RTP ENVIRONMENTAL ASSOCIATES INC.®

May 10, 1995

Re: Florida Crushed Stone Incompleteness/Insufficiency Review
File No. PSD-FL-227 and PA 82-17

FIGURE A

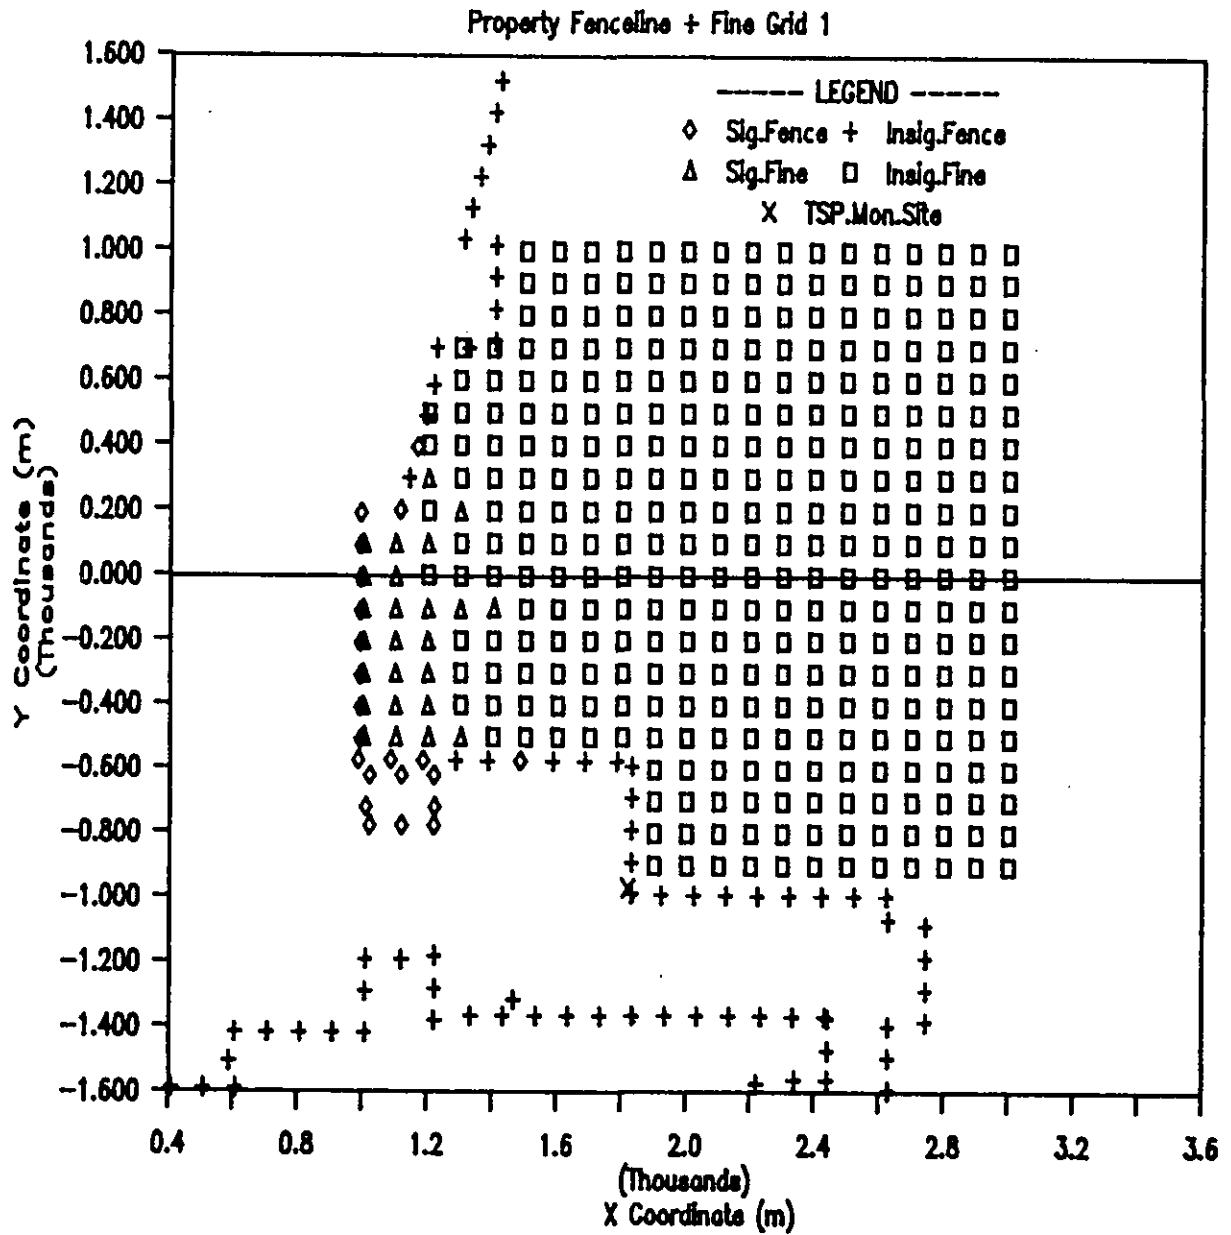
In order to determine the extent of significant 24-hour PM impacts, the fine grid receptors (out to 3 kilometers) shown as Attachment 4 to the April 12, 1995 letter to Cleve Holladay were modeled with ISCST2 and all five years of meteorological data. These maximum impacts are included on Table C. Figure A shows those receptors with 24-hour PM impacts greater than the 5 $\mu\text{g}/\text{m}^3$ SIL. As can be seen, the area of significant impacts is quite small, approximately one-third of a square kilometer immediately outside the property fenceline.

The maximum 24-hour PM impact from the three modeled minor PM sources is 8.36 $\mu\text{g}/\text{m}^3$, predicted to occur at the property fenceline. This maximum minor source impact is less than the TSP and PM_{10} Class II increments of 37 and 30 $\mu\text{g}/\text{m}^3$, respectively. This area of significant minor source PM impacts is very close to one of the two TSP monitoring sites (1740-005) maintained by the applicant as shown on Figure A. Adding the maximum second-highest background TSP concentration measured at this monitoring site of 67 $\mu\text{g}/\text{m}^3$ (see Table 5-3 of the air permit application) to the maximum second-highest 24-hour impact of 6.68 $\mu\text{g}/\text{m}^3$ (in the fine grid) gives a maximum 24-hour total concentration of 74 $\mu\text{g}/\text{m}^3$, which is considerably less than the TSP and PM_{10} AAQS of 150 $\mu\text{g}/\text{m}^3$.

Therefore, compliance with AAQS and Class II increments are indicated for the minor PM sources. As shown on Figure A, the TSP monitoring site is close to the significant impact area. Since this monitoring site has and will continue to measure impacts from existing sources, including the various FCS operations, multisource modeling analyses should not be required to demonstrate compliance with AAQS.
